Florence Golf Links

Preliminary Planned Unit Development (PUD)
&
Tentative Subdivision Plat (SUB)

PC 20 07 PUD 01

PC 20 08 SUB 01

ATTACHED HOUSING: CONCEPT B2 – 2 UNITS

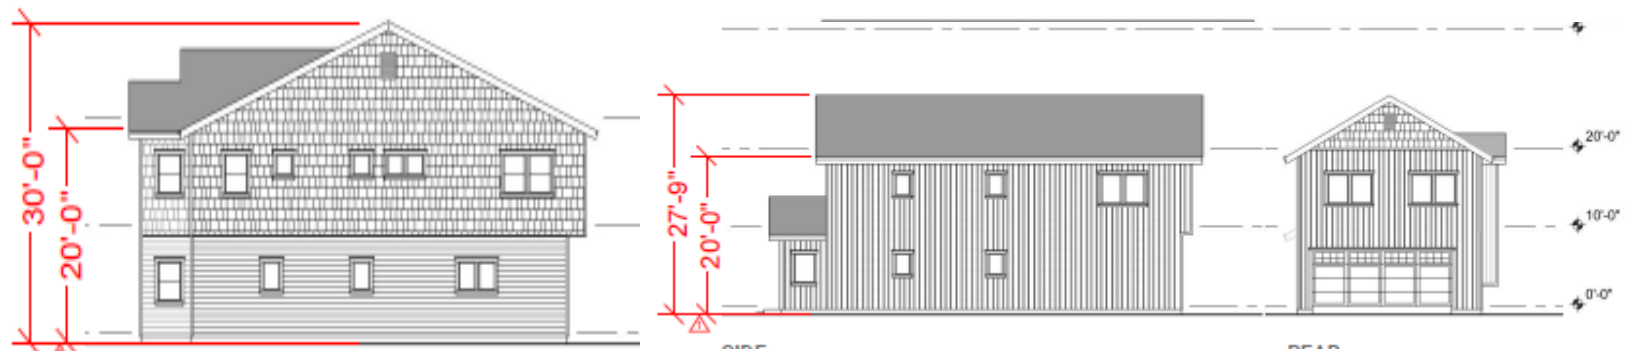
#7 Design Review for multi & attached housing

#8. Meet or Exceed Architectural Standards for Detached Single Family

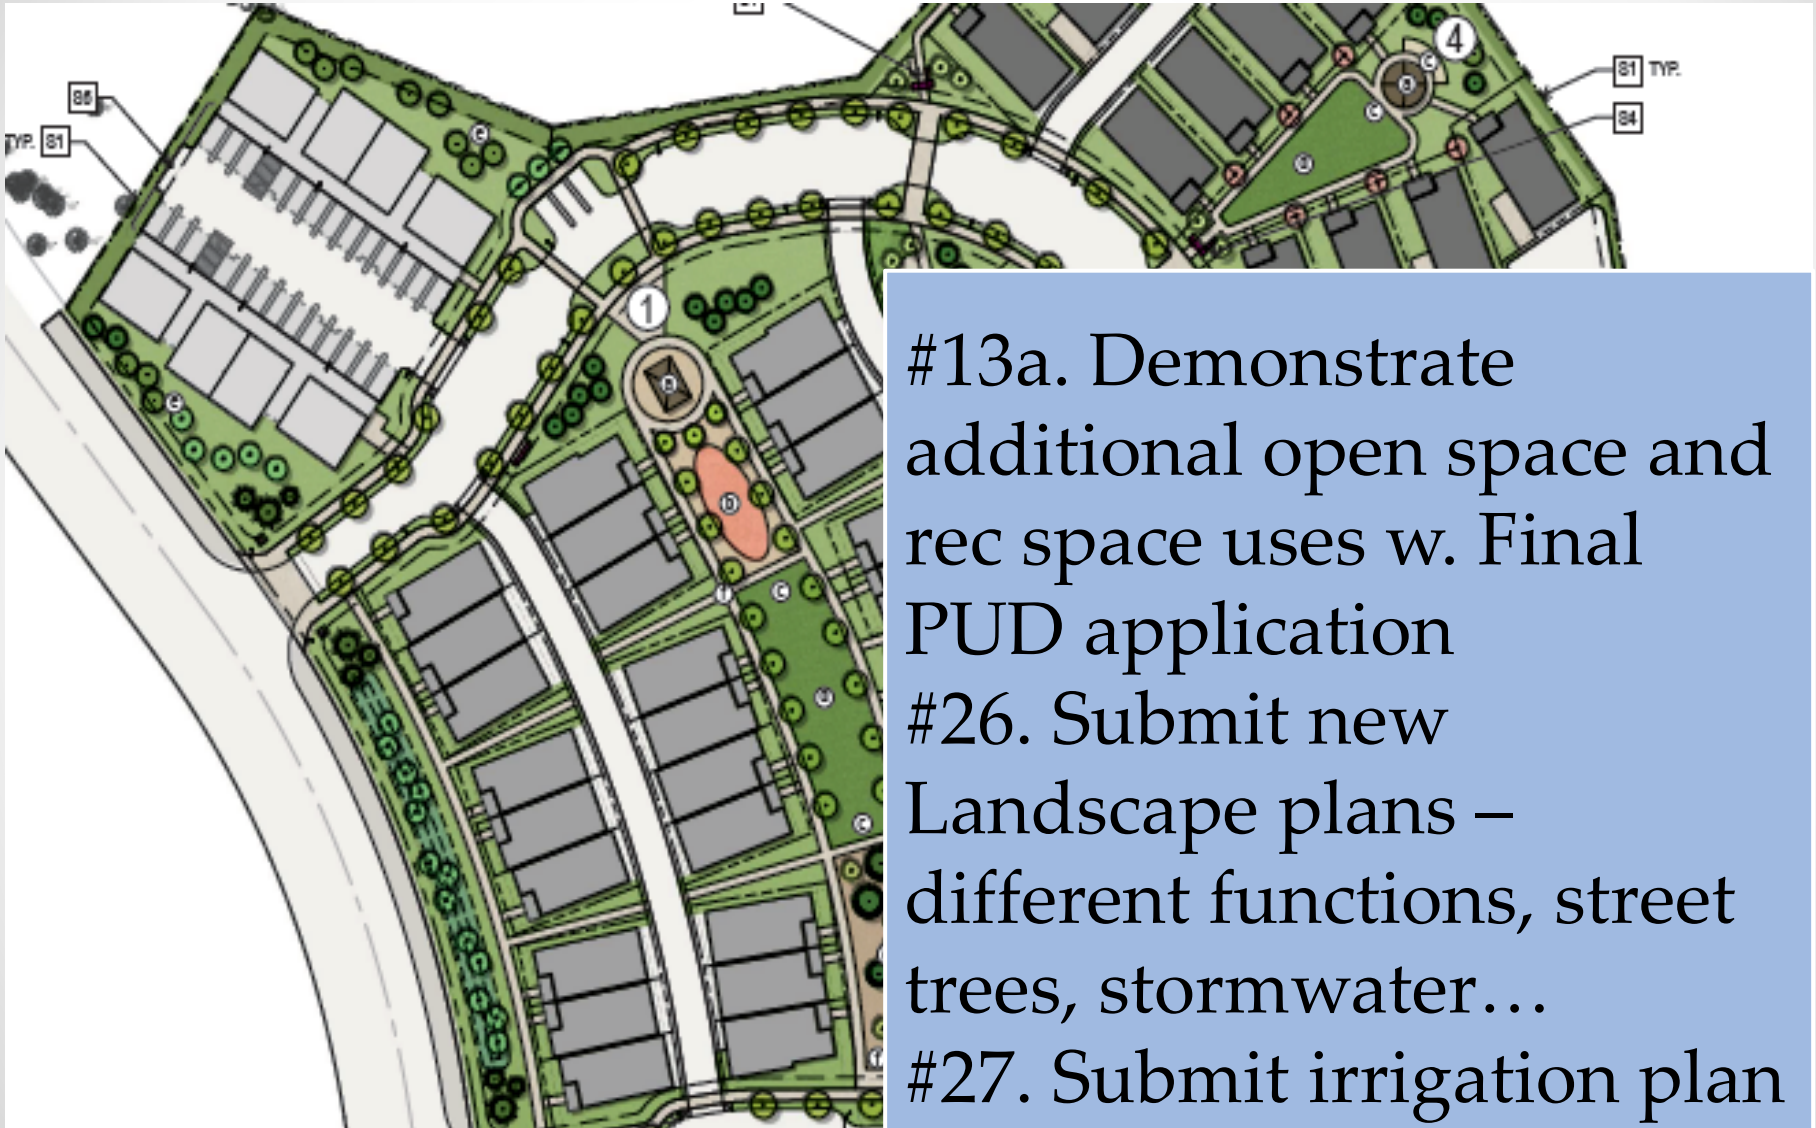
#10 Label and Dimension Porch areas for Final PUD

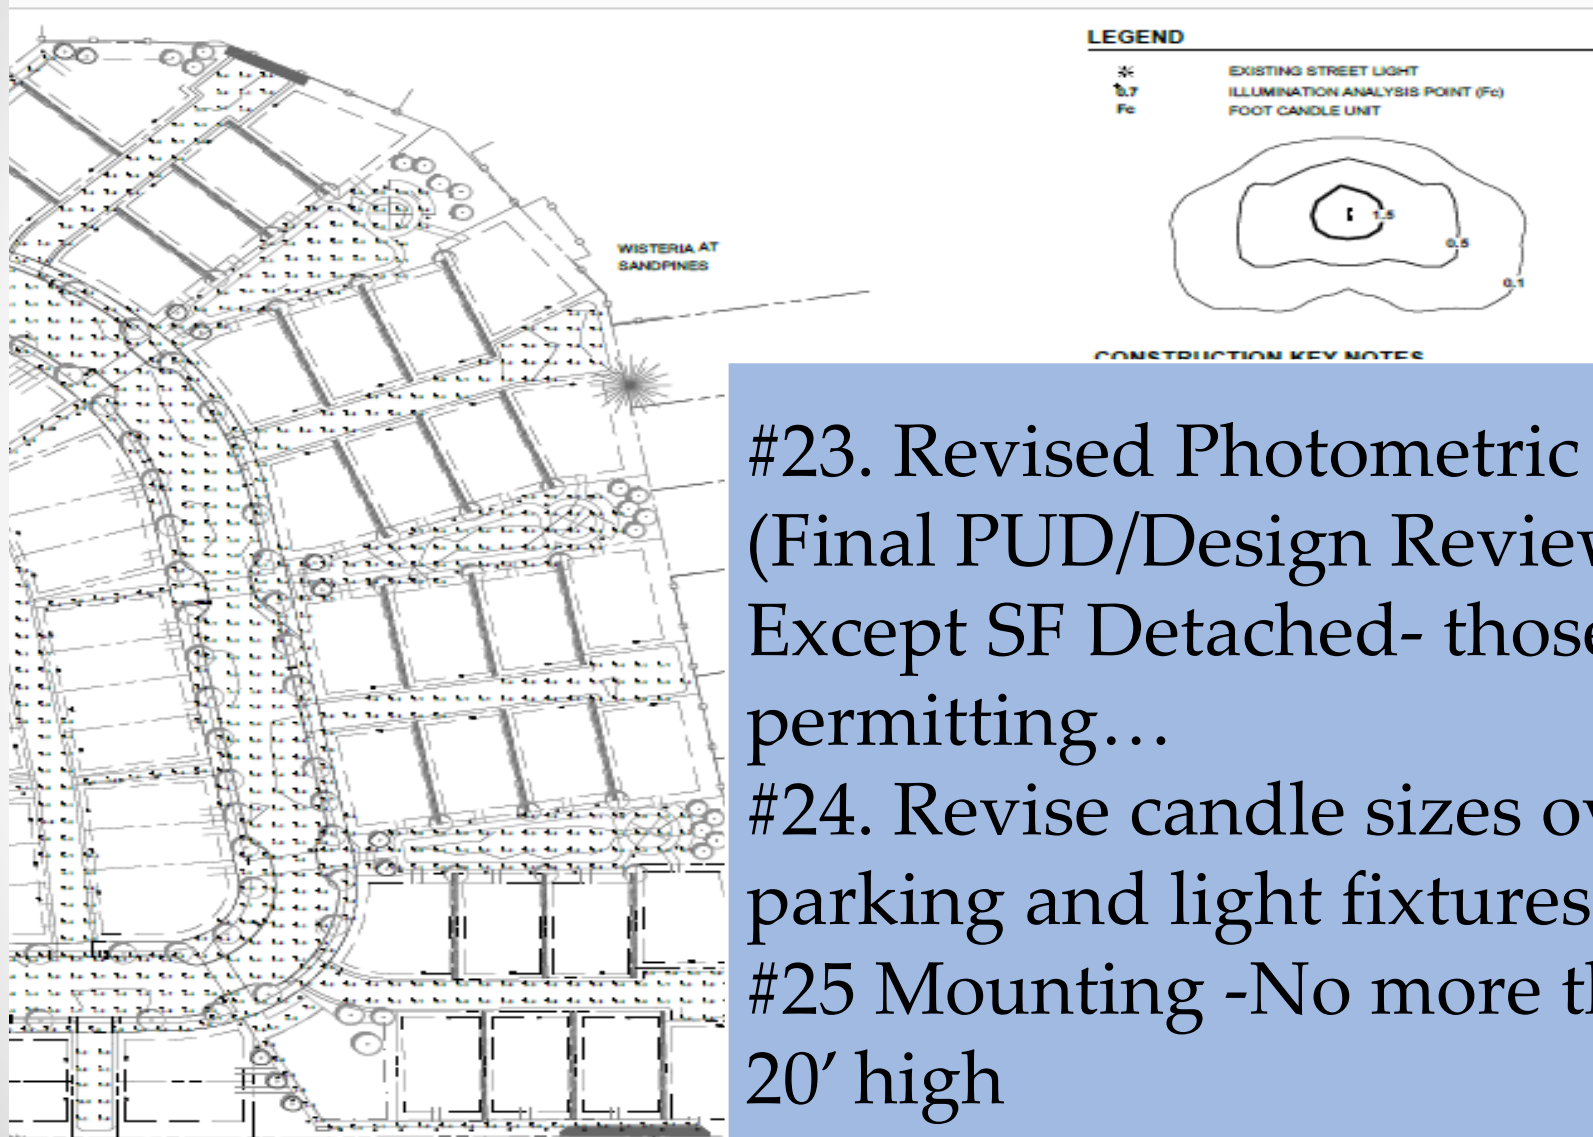
#4. Dimensioned Parking Plan w/ final PUD
#6. Bike Parking Signage Plan prior to permitting

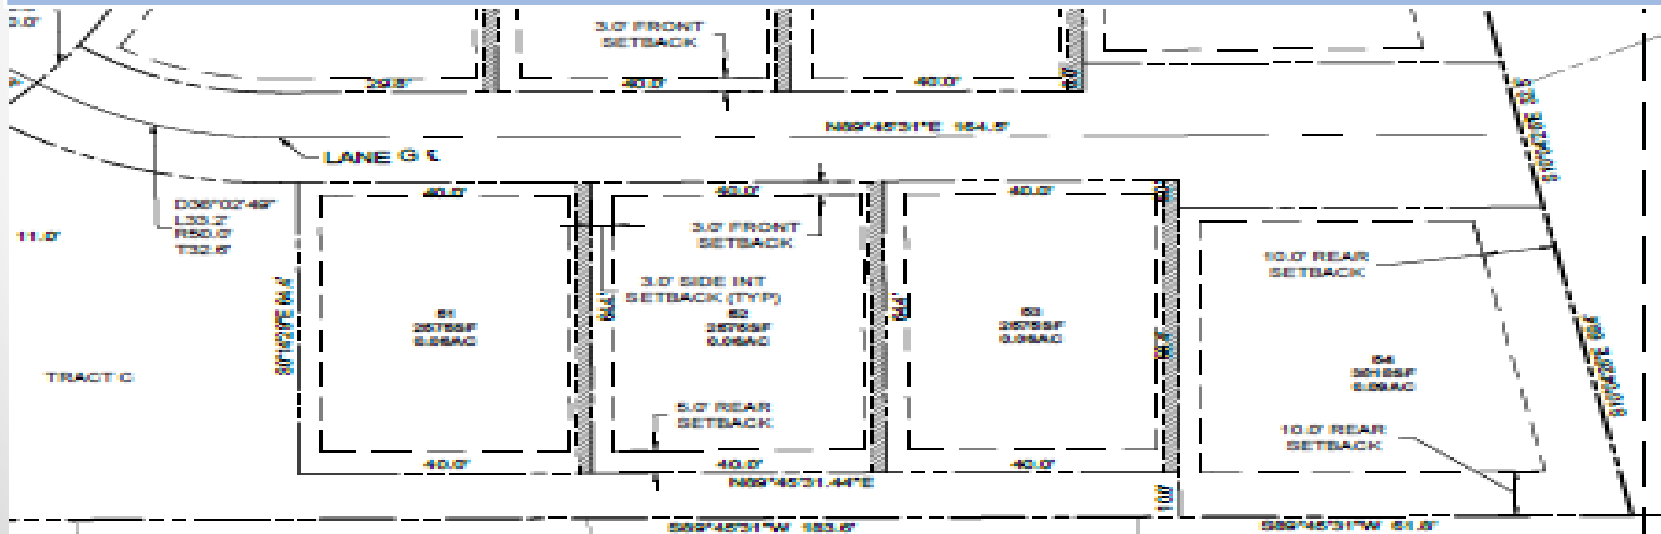
- #5 Maintenance Easements, CC&Rs
- #16 Notations/Label for Ownership & Conveyance
- #18 Label curb radii
- #28 Loop Dr. & Final Plat Name?
- #29 Provide Affidavit of Services
- #33 Label correct setbacks- side v. rear.

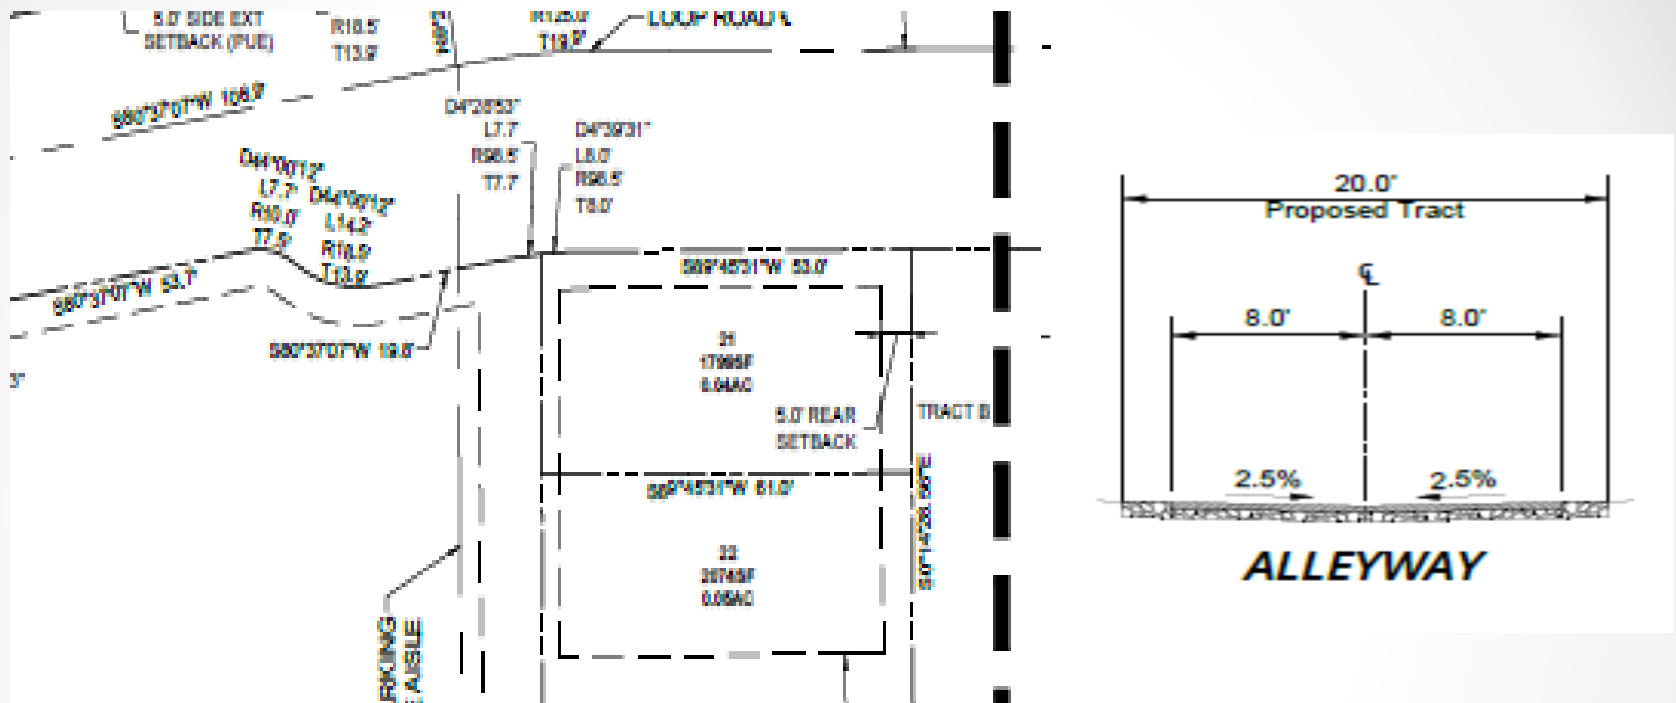
- #14. Lot 22 not Lot unless Tract is labeled.
- #14a. Re-label cross section to “Proposed ROW” and “Tract”
- #15 Correct Rhody cross section
